Addendum to IDAC report for PLN18/0328 – 459 – 471 Church Street & 20-26 Brighton Street Richmond

The following discussion relates to drainage matters and is an addendum to the IDAC report dated 27 February 2019.

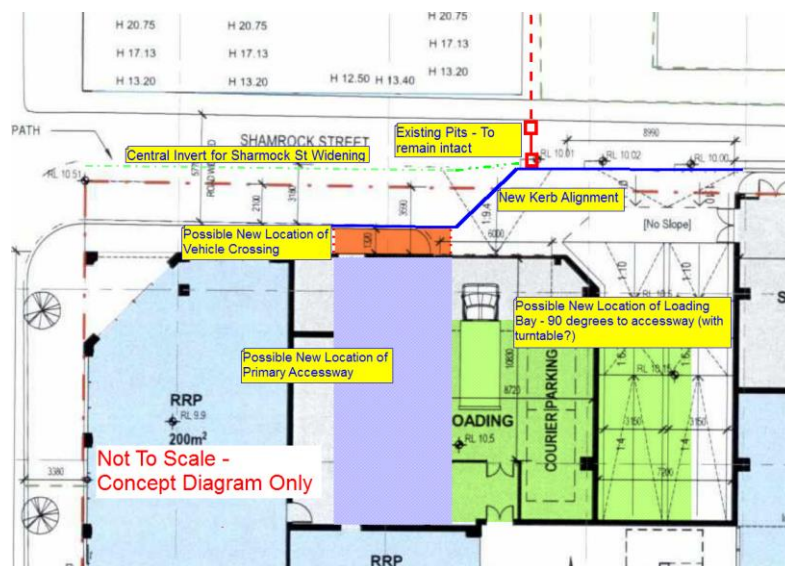
Turning to the widening of Shamrock Street. Council's civil engineers identified this as a significant issues. As a result of the widening, two existing grated side entry pits (located 24m to the east of Church Street) would be impacted. These pits are located at the lowest point in Shamrock Street which connects into a drain that runs underneath properties on the east side of Church Street and continues to Lesney Street. The inlet capacity of the southern grated side entry pit would be reduced as a result of the widening of Shamrock Street due to the removal of the lintel and the throat. Council's civil engineers stated that it is vital that the pits remain intact as they are critical in collecting rainfall run-off for the Shamrock Street catchment area. Council's civil engineers recommended that the principal vehicular entrance be relocated further west. As the development entrance would be located in the vicinity of the low point in Shamrock Street, Council's civil engineers also recommended that a central invert be constructed in the widened section of Shamrock Street. As a result of these recommendations, the principal vehicle entrance and loading bay need to be redesigned and the length of the Shamrock Street widening be reduced from what was originally proposed. Council's civil engineers provided the following diagram:
